Subject: Review of revised IM—Effects of Environmental and Metallurgical Conditions on the Passive and Localized Dissolution of Ti-0.15Pd, Intermediate Milestone 01402.571.010

Reference: Letter from T. Ahn to V. Jain, April 12, 2001: Acceptance of Intermediate Milestone 01402.571.010 “Effects of Environmental and Metallurgical Conditions on the Passive and Localized Dissolution of Ti-0.15Pd”

EFFECTS OF ENVIRONMENTAL AND METALLURGICAL CONDITIONS ON THE
PASSIVE AND LOCALIZED DISSOLUTION OF Ti-0.15Pd

Bonasia & Cragolino, figure 9

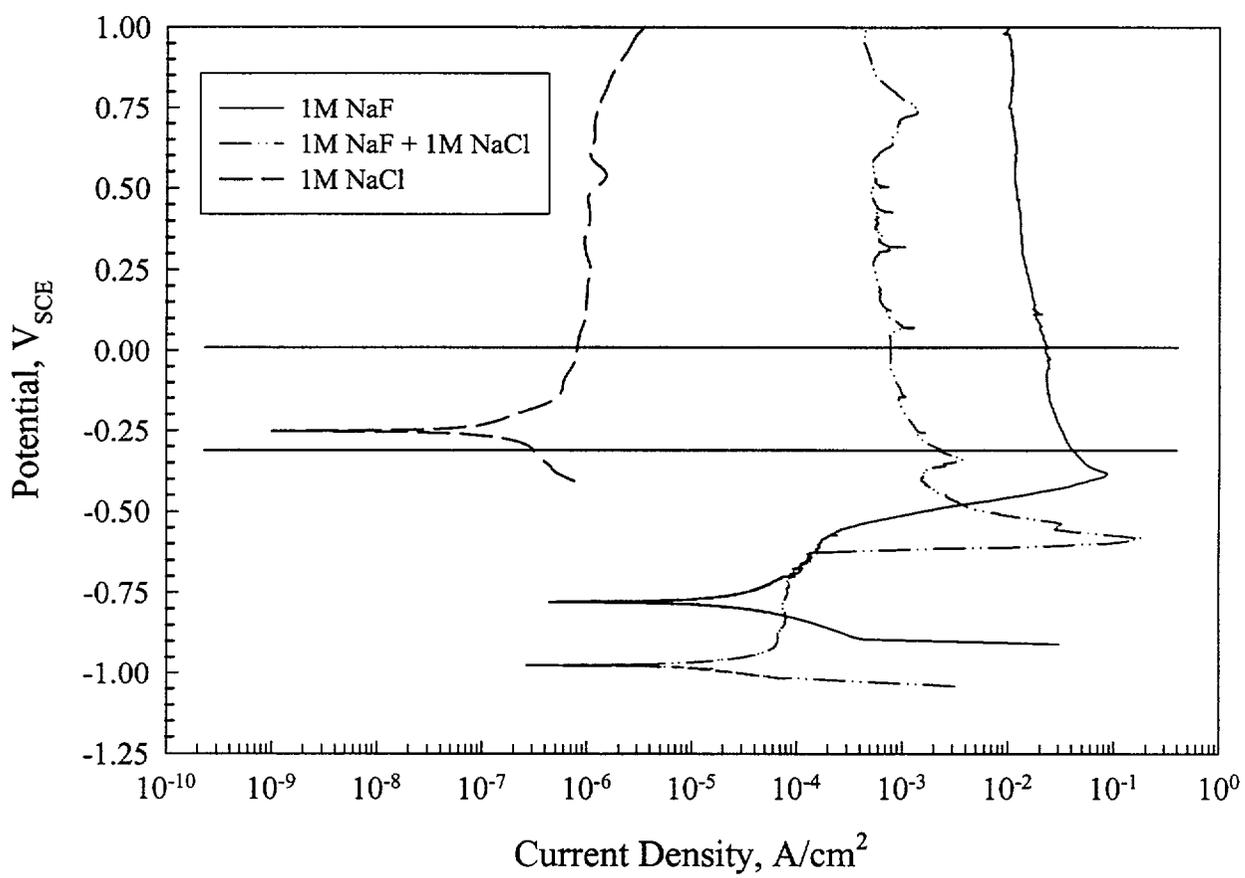
- (1) **Clarify on page 8, there are 4 solutions listed in reference to figure 9 that has 3 curves; the paragraph starting with "Also" states 2 dashed lines referenced in figure 9 that has no dashed lines.**

Accept. This has been clarified in the test.
